Attention: May Li, Assessing officer,
Lane Cove Council
PO Box 20 Lane Cove
NSW 1595

Your ref: DA11/233

**RE: Development Proposal 7-13 Centennial Ave & 92-96 Gordon Street Lane Cove
SEPP 65 COMMENTS AND RECOMMENDATIONS**

Building B shadow study 9:00 am 12:00 and 3:00pm

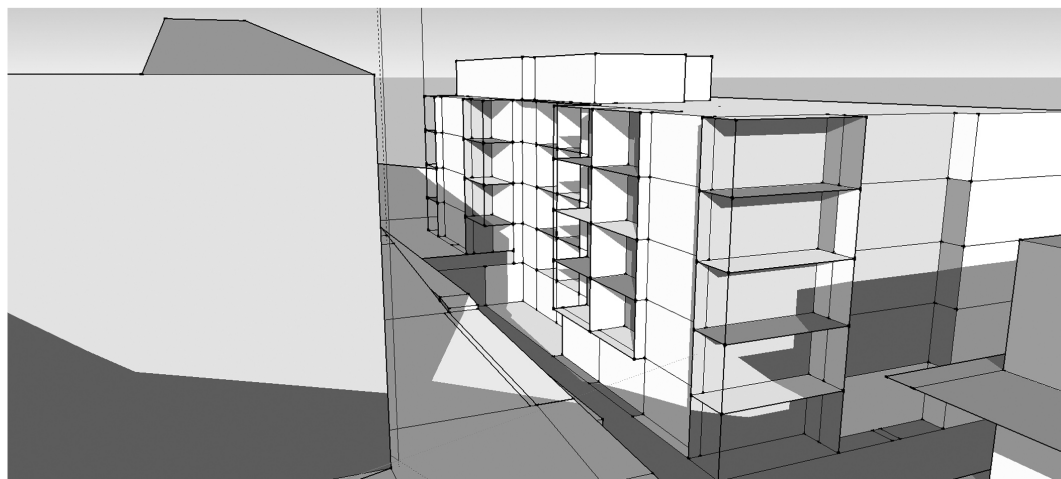
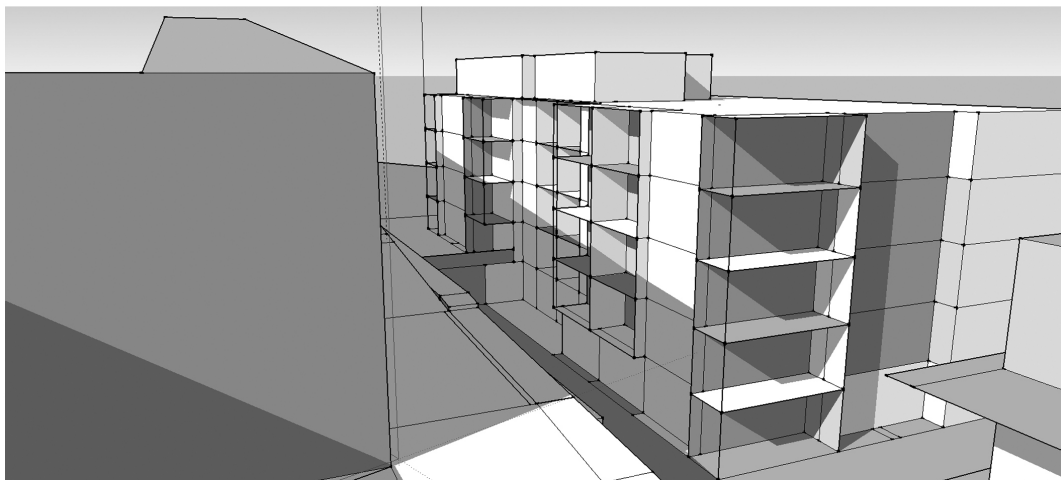
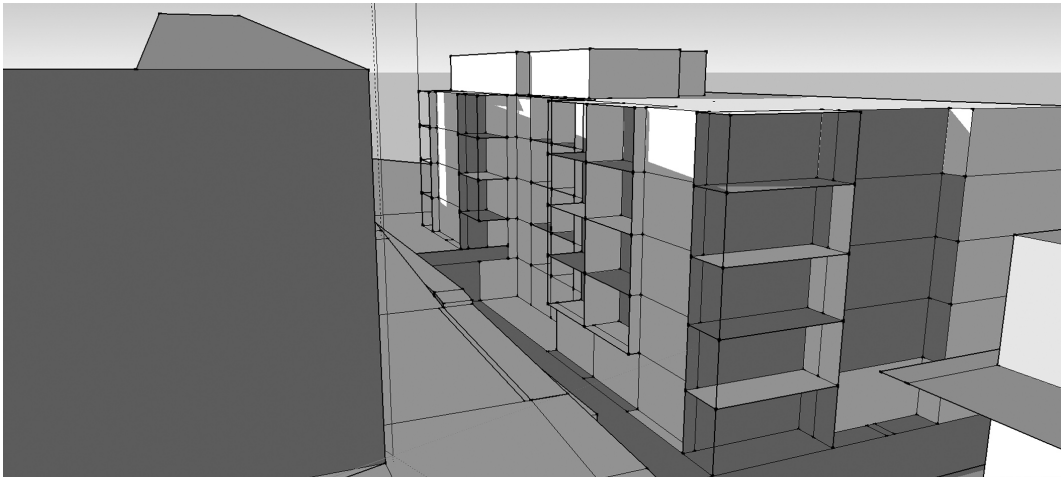
The site to the south of the site will be largely overshadowed by the development and will only receive partial sun after 2:00pm in winter.
